# Access Compliance Report Public Rights-of-Way (Curb Ramps)

| Main Street: E_SPRING_ST                |                              | Cross Street: EARLHAM_ST |                                         | Location:       | SE |
| ADA ID: RPAT210927111112                | Ramp Type: Type 4 - Parallel | Initial Pass/Fail: Fail  | Overall Compliance: No                  | Severity Score: | 4  |

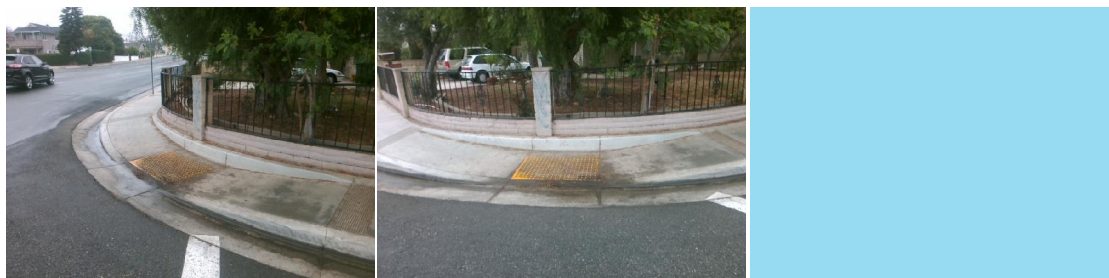
| Compliance | Description                   | Data       | Compliance | Description                   | Data |
|------------|-------------------------------|------------|------------|-------------------------------|------|
| Yes        | Ramp Width LT (in)            | 48         | No         | Ramp Width RT (in)            | 47   |

**Remove & Replace Curb Ramp With Two New Directional Ramps or Equivalent.**

**R304.5.1, STD 1115**
